**BID SET
12/10/2010
ADDENDUM
NO. 2**

CITY OF BEAUMONT
 BUILDING-D
 ELECTRICAL RENOVATION WORK
 FLOOR PLAN FOR LIGHTING

SHEET NO. 4
 E-4
 OF 4 SHTS.
 FILE NO.
 1890

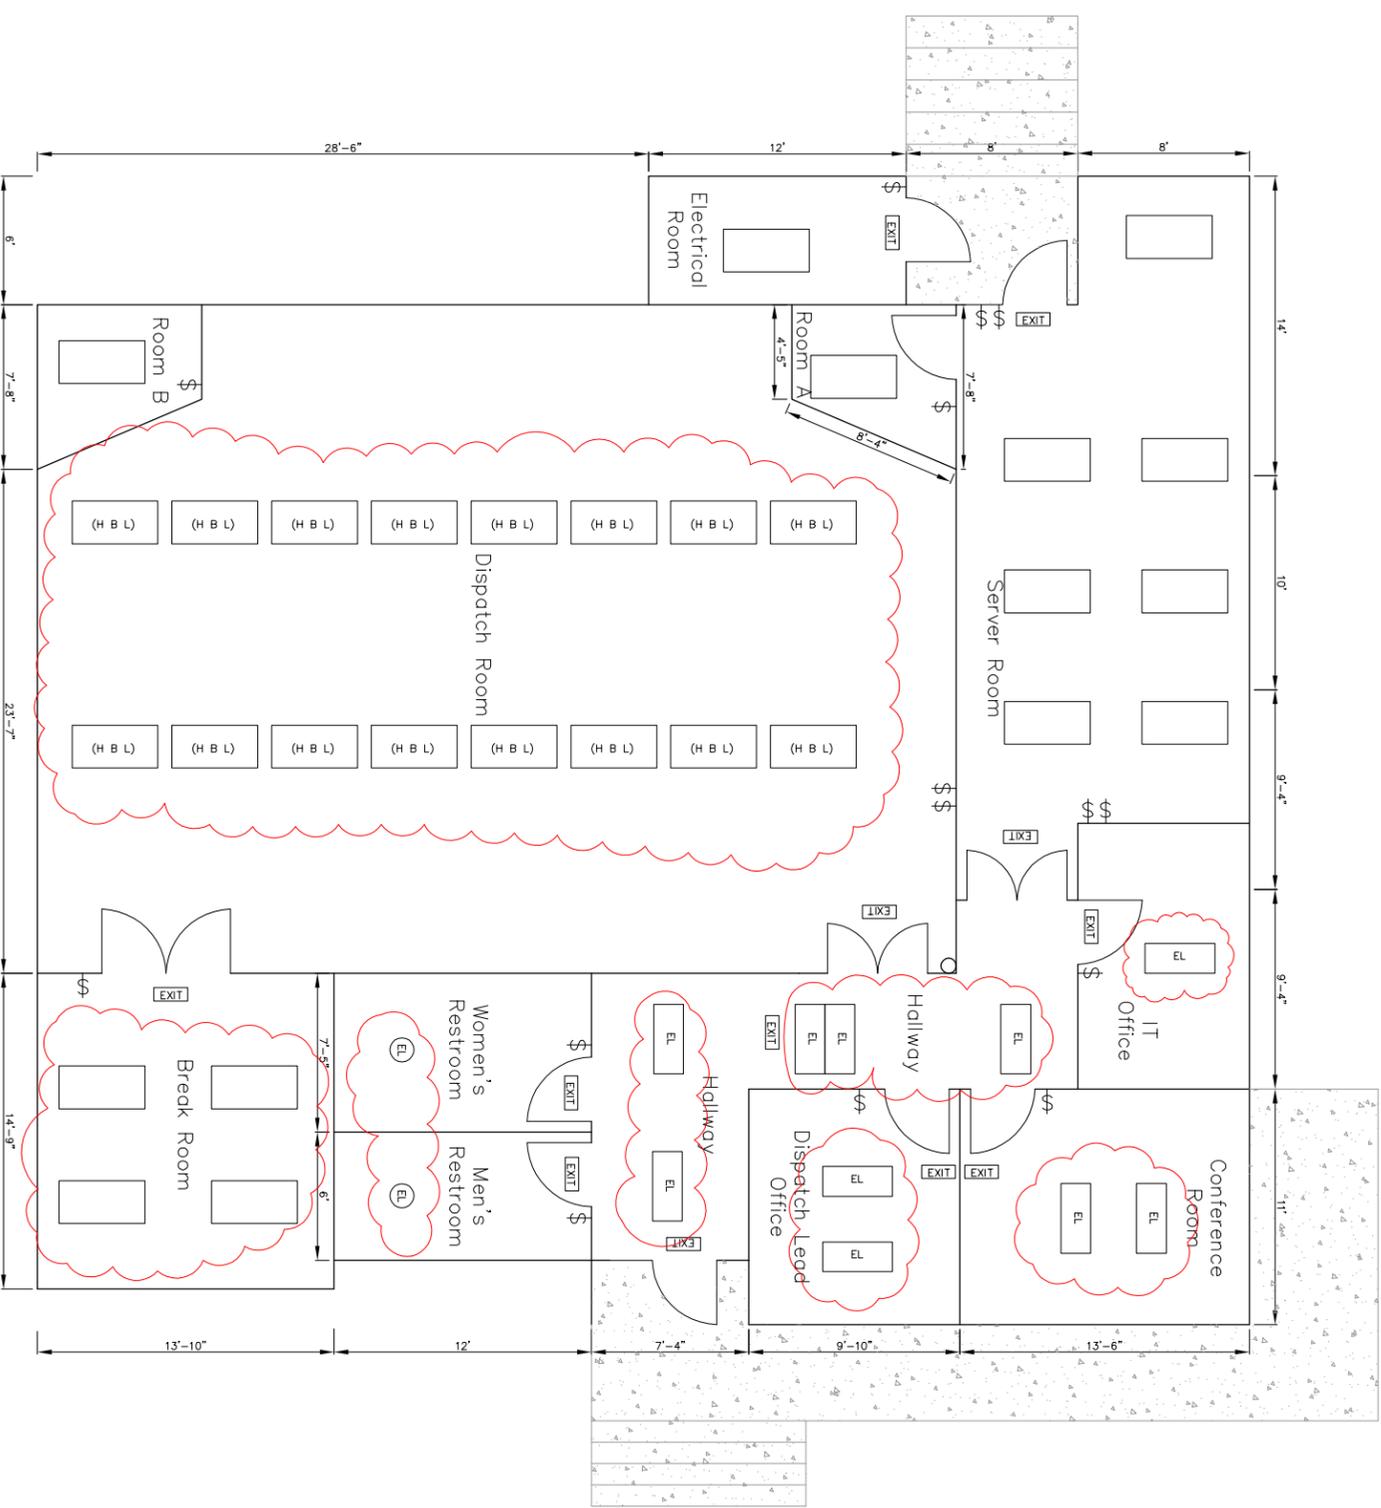
PROVIDE COMPLETE WIRING TO THE ALL LIGHTINGS INSIDE THE BUILDING-D FROM PANEL DP-M DEDICATED CIRCUITS FOR LIGHTINGS IN COMPLETE INCLUDING LAMP FIXTURES, FITTINGS AND ALL ACCESSORIES PER NEC AND ALL CALIFORNIA AMENDMENTS
 PROVIDE DIMMING BALLAST FOR DISPATCH ROOM
 PROVIDE OCCUPANCY SENSORE IN ALL AREAS
 LOCATION OF LIGHTING FIXTURES MAY BE PROVIDED BASED ON AREA SQ.FOOT REQUIREMENTS.
 ALL MATERIALS SHALL BE NEMA STANDARD & UL RATED. LOCATIONS ARE APPROXIMATE AND NEED FIELD VERIFICATION.
 PROVIDE ADDITIONAL LIGHTINGS, IF REQUIRED PER CITY AUTHORITY.
 PROVIDE PANEL SCHEDULE COPY AT THE INSIDE DOOR OF ALL PANELS.
 SUCCESSFUL BIDDER TO REVIEW EXISTING HVAC, PLUMBING, F.S. ETC. CONDITION PRIOR TO SHOP DRAWING DRAFTING.
 SUCCESSFUL BIDDER TO COORDINATE WITH HVAC SUB-CONTRACTOR ETC.
 SUCCESSFUL BIDDER/SUB-CONTRACTOR TO PROVIDE (2) SAMPLES OF EACH ITEM AS APPLICABLE ALONG WITH PRODUCT DATA SHEET (WITH SWITCH REC. ETC.) (1) ITEM WILL BE RETURNED TO SUB-CONTRACTOR AFTER AWARD OF CONTRACT PRIOR TO PROCUREMENT.

REVISIONS ARE CLOUD MARKED
